TfNSW reference: STH25/00057/002  
Your reference: DA2024/0172 (CNR-78671)

**DA2024/0172 – Multi-unit dwelling development – LOT: 1 DP: 199162 – 75 Fitzroy Street, TUMUT**

Attachment 1

Attachment 2

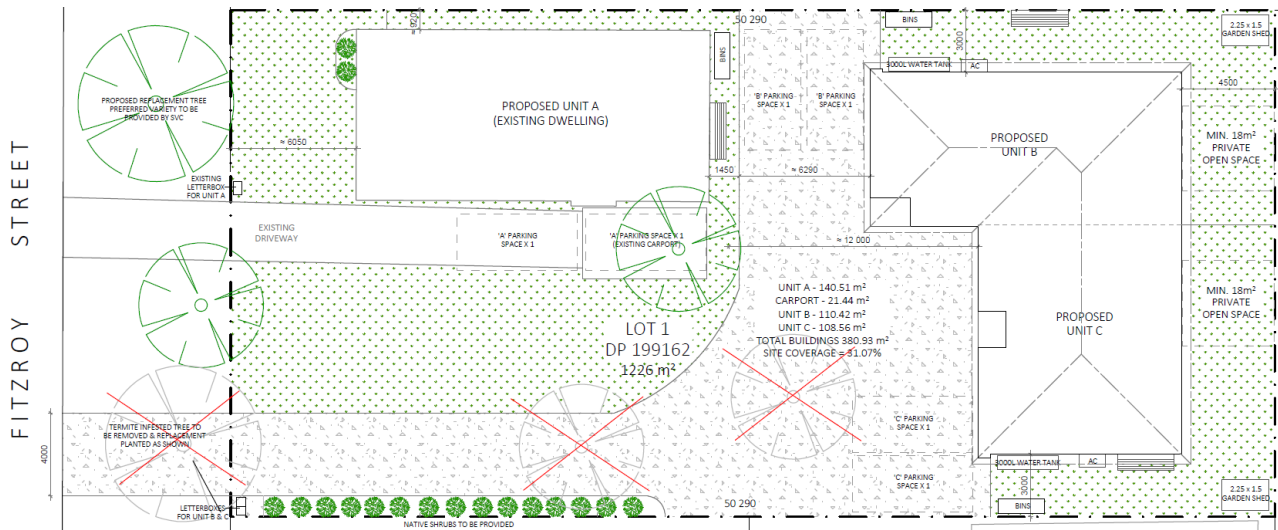
- The key classified state road is Snowy Mountains Highway. Fitzroy Street forms part of the Snowy Mountains Highway, is an approved B-Double route and in this location has a 50 km/h speed zone.
- Council is seeking advice from TfNSW to assist in its assessment under Section 138 of the Roads Act, 1993.
- The development proposes multi-unit dwelling located on a single lot, which will feature the existing dwelling and two newly constructed units at the rear as set out in **Attachment 2**. TfNSW highlights there are conditions in this letter addressing proposed access arrangements.

1. A maximum of 1 driveway to Fitzroy Street is permitted to provide for shared vehicular access to the proposed development consisting of the existing dwelling and the additional 2 units.

2. The access driveway shall be a minimum width of 5.8m to provide for 2-way movement for its full length from the kerb and gutter to comply with the requirements of Australian Standard AS 2890.1 - Off-street Parking. An updated plan is to be submitted to the satisfaction of Council.

3. The proposed access driveway is to be constructed so that the driveway rises to the level of the pedestrian footpath along the frontage of the site and not have the footpath step down onto the roadway.

4. For road safety reasons the access driveway and the internal layout of the development shall be designed to allow all vehicles to enter and exit the subject site in a forward direction and not be required to reverse onto the road reserve of Fitzroy Street.

5. Following the construction of the new access driveway the existing driveway to the subject site is to be removed and the road reserve is to be reinstated to match the surrounding roadside landform including kerb & gutter in accordance with Council requirements.
